Director City Planning Report No. CP79/17

Subject: 8 Norton Street, Kingsford (DA/703/2016)

Proposal: Alterations and additions to the existing dwelling including new first floor, construction of carport to western side of dwelling with associated works.

Development Application Executive summary report

Figure 1: Existing and proposed shadow diagrams

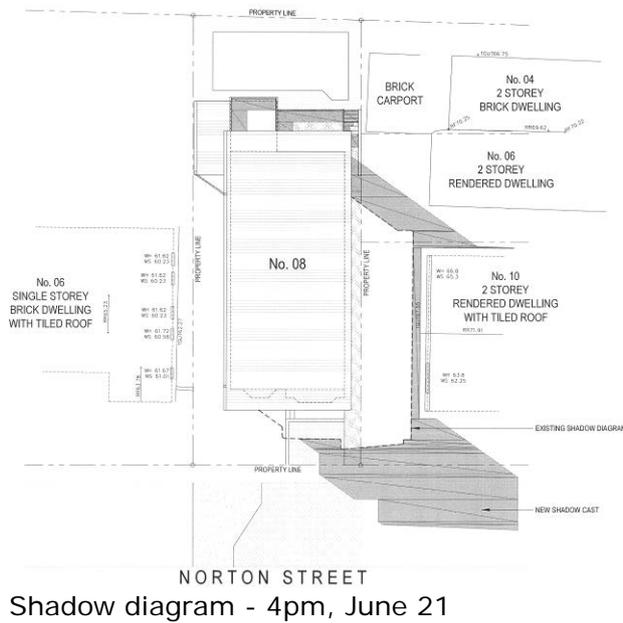
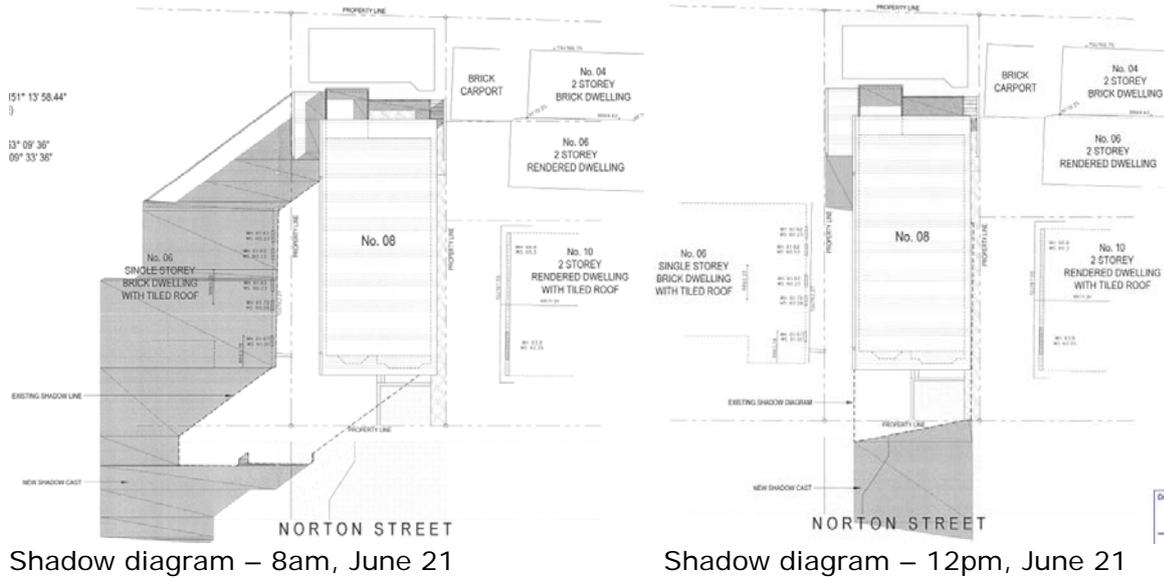
A submission was received from the neighbouring properties at no.'s 6 & 8 Kennedy Street objecting to the development on the grounds that it will cause additional overshadow impacts in the afternoon to their principle private open spaces which is located at the rear of their property.

The shadow diagrams submitted demonstrate that solar access to the principal outdoor recreation space to the rear yard on the subject site will still receive a minimum of 3 hours of direct sunlight between 8am and 4pm on 21 June.

Whilst it is noted that there will be additional overshadowing impacts in the afternoon to the objector's properties as a result of the proposed development, the additional overshadowing impacts when compared to the existing are not significant and the neighbouring property at no. 6 Kennedy Street will still receive a minimum of 3 hours of direct solar access to at least 50% of the rear yard in the afternoon. In relation to the neighbouring property at no. 8 Kennedy Street the shadow diagrams below demonstrates that majority of the yard in the afternoon is already overshadowed by the existing development due to its east west orientation and when taking this into consideration the development will not be resulting in any unreasonable additional impacts.

Figure 2: View looking due west to the subject site from the ground floor rear living area at no. 6 Kennedy Street. (Photo taken by Solution Zane)

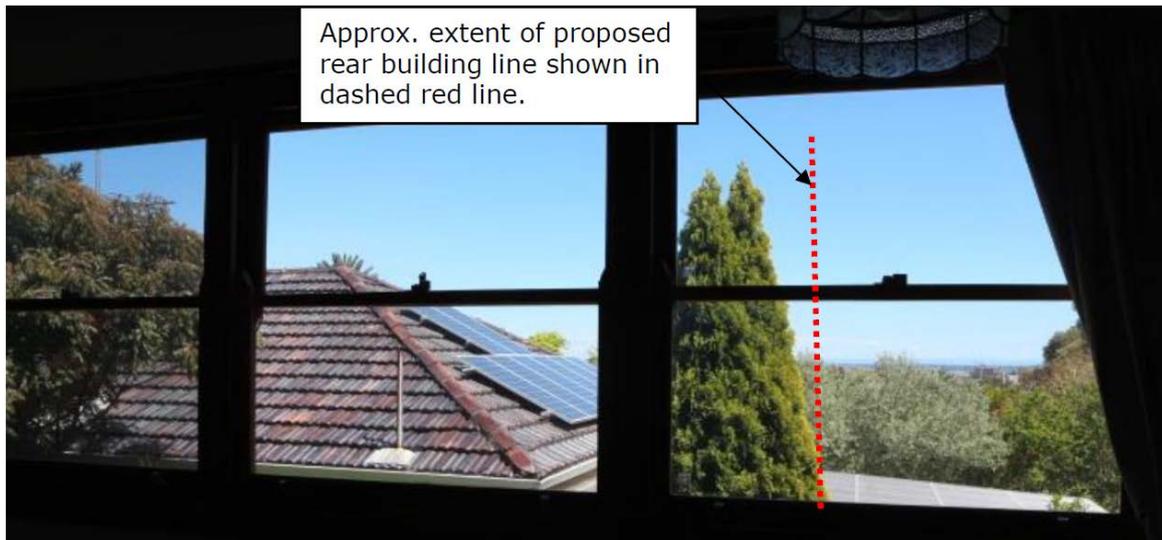
The image below in figure 2 demonstrate that the view looking due west to the subject site from the ground floor rear living area at no. 6 Kennedy Street will be partially lost. Some of the views to the north west will be retained.

Figures 3 & 4 demonstrate that the view over the subject site from the first floor bedroom at no. 6 Kennedy Street will be retained.

Given that the views are not iconic and are mainly district views the impacts associated with the proposed development are not unreasonable and will meet the objectives of the view sharing control.
